Nine Mile Point Nuclear Station

SUBJECT: Nine Mile Point Units 1 and 2
Docket Nos. 50-220 and 50-410
Facility Operating License Nos. DPR-63 and NPF-69

License Renewal Application – Responses to Previously Unanswered NRC
Requests for Additional Information (TAC Nos. MC3272 and MC3273)

Responses to NRC Requests for Additional Information (RAIs) Related to:

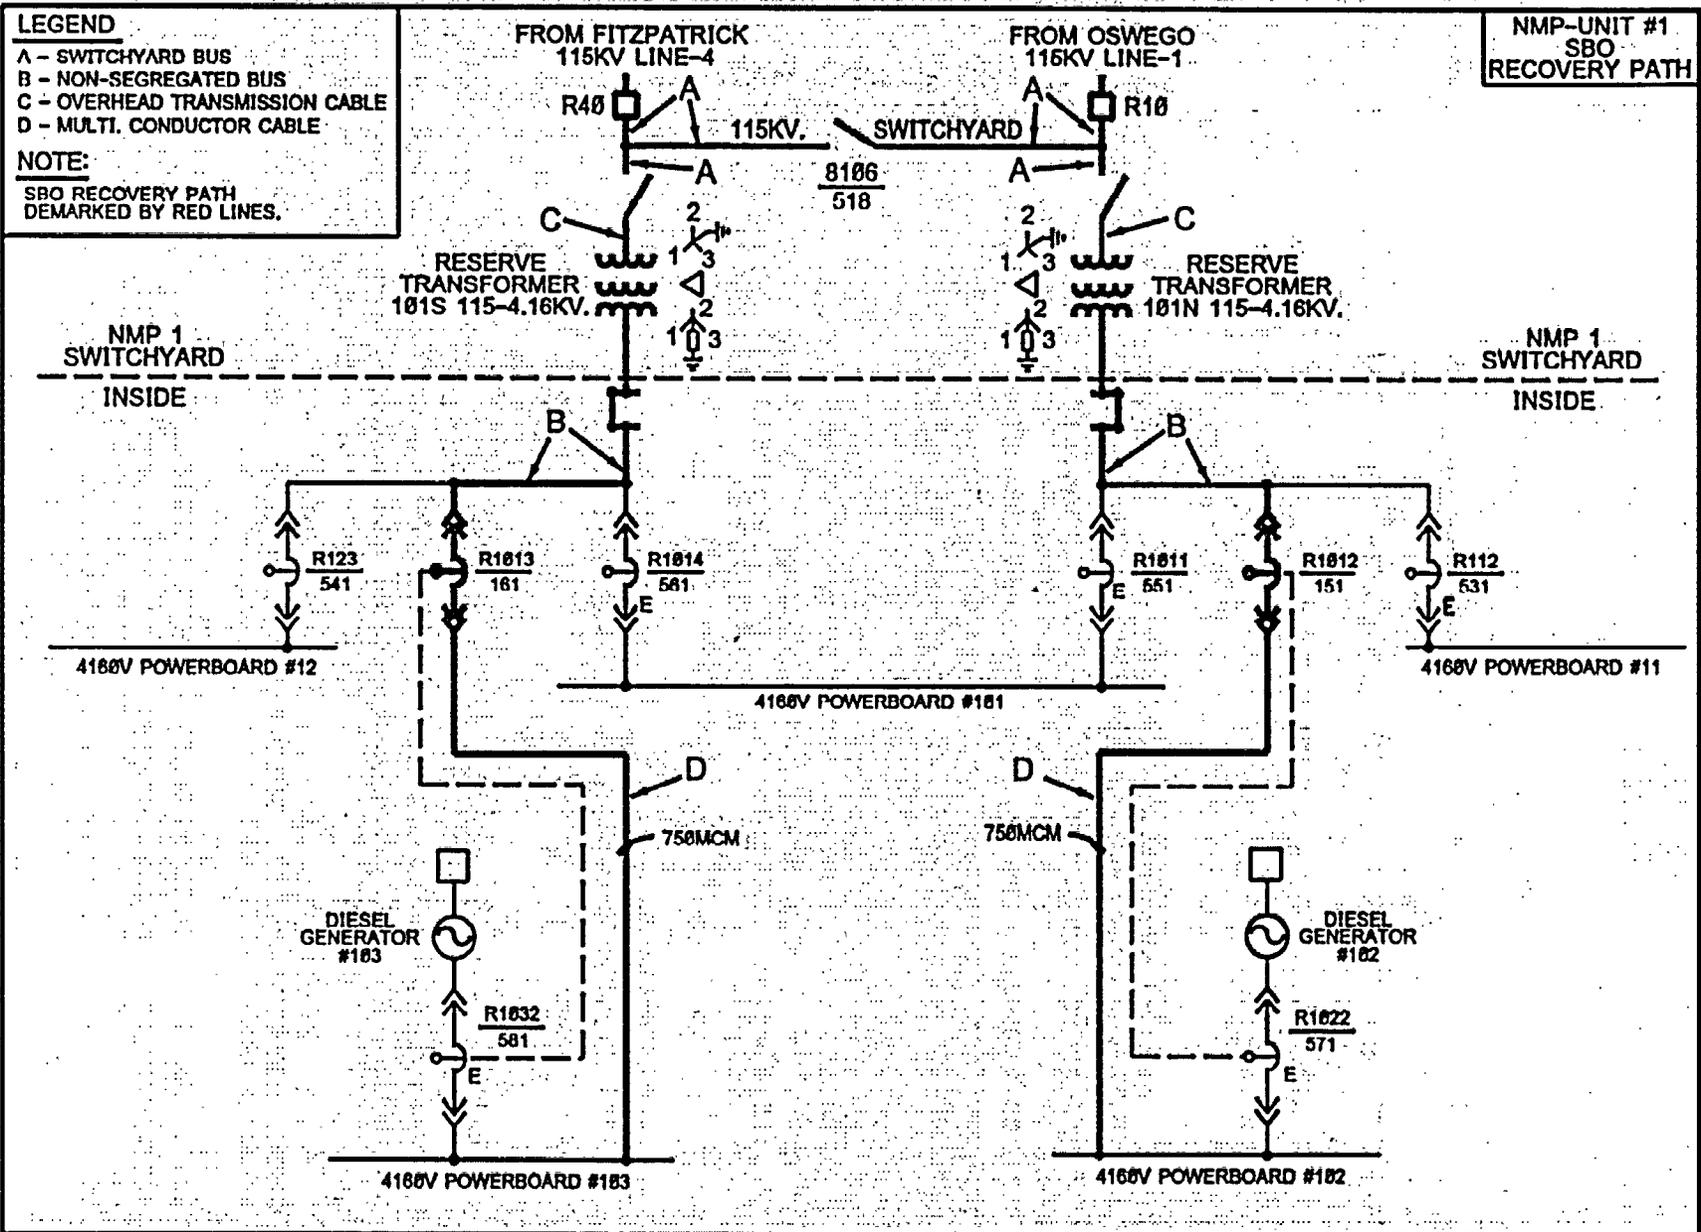
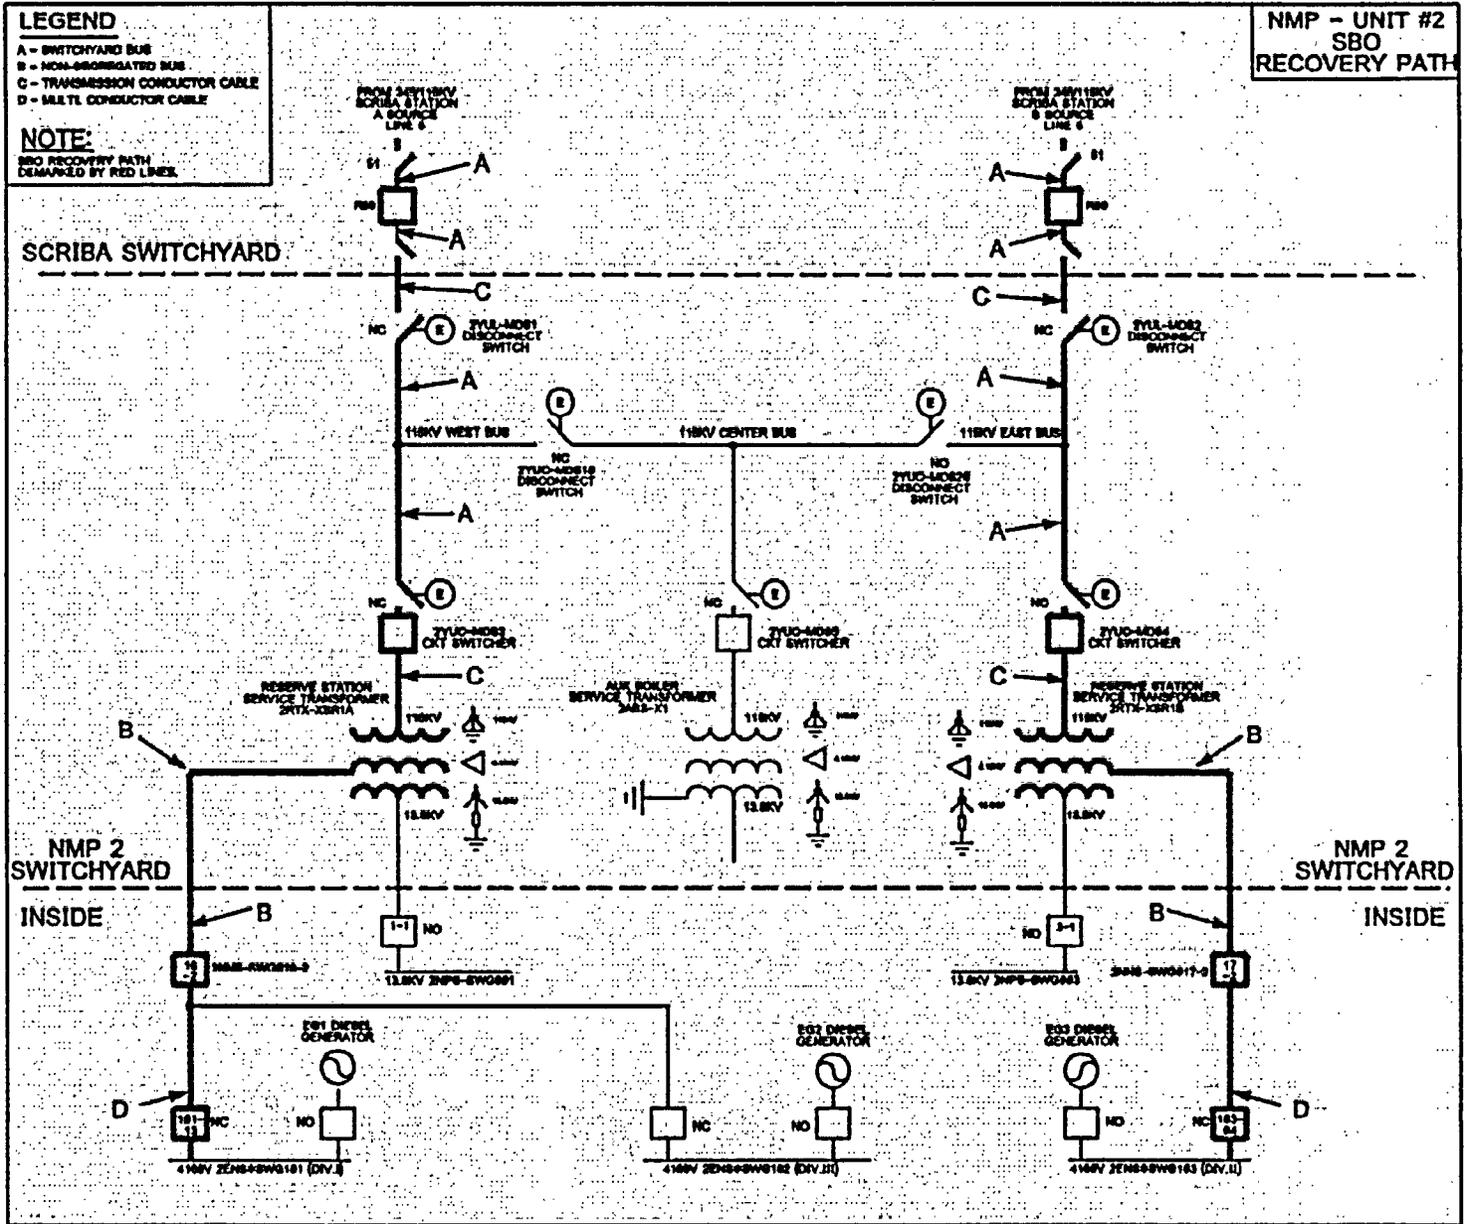
- A. *Please provide a detail description of the NMP recovery path and discuss how the recovery path is consistent with scoping and screen results described in Section 2.5 of the LRA. Also, please provide a one line diagram with redline showing the recovery path of Station Blackout (SBO).*

Diagrams of the NMP1 and NMP2 offsite circuits with the SBO path shown in bold are attached. These diagrams correspond to the descriptions of the SBO recovery path provided below. The identification of each commodity group component, as requested in Item B of the RAI, is included in the unit specific Part A response.

- LRA Section 2.5.C.1, “Cables and Connectors,” identifies cables on a plant-wide basis, including accessible and inaccessible medium voltage cables. Cables and connectors in the SBO recovery path are included in this electrical commodity. This includes the SBO cables and connectors from breaker R1013/161 to power board 103 and from breaker R1012/151 to power board 102.

- LRA Section 2.5.C.1, “Cables and Connectors,” identifies cables on a plant-wide basis, including accessible and inaccessible medium voltage cables. Cables and connectors in the SBO recovery path are included in this electrical commodity. This includes SBO cables and connectors from breakers 2NNS-SWG016-2 and 2NNS-SWG017-2 to switchgear 2ENS*SWG101 and 2ENS*SWG103.

- LRA Section 2.5.C.2, “Non-Segregated/Switchyard Bus,” identifies the switchyard bus, the non-segregated bus, and insulators as subject to AMR review. This includes the following SBO components. Scriba switchyard (115 kV) bus, NMP2 115 kV switchyard bus and non-segregated bus from reserve 2RTX-XSR1A to 2NNS-SWG016-2 and from reserve transformer 2RTX-XSR1B to 2NNS-SWG017-2.

- LRA Section 2.5.C.4, “Switchyard Components,” identifies the components subject to aging management review (AMR) within the switchyard as the transmission conductors and the insulators and connectors associated with them. Cables, connectors, and bus bars are evaluated in their respective commodity groups. This includes SBO transmission conductors, insulators and connectors from 115 kV Scriba switchyard (lines 5 and 6) to the NMP2 115 kV switchyard and from the NMP2 115 kV switchyard to the reserve transformers 2RTX-XSR1A and 2RTX-XSR1B.

The commodity group component types in the NMP1 and NMP2 SBO recovery path circuits are identified on the attached one line diagrams. These commodity group component types are switchyard bus, non-segregated bus, overhead transmission conductor and multiple conductor cable.
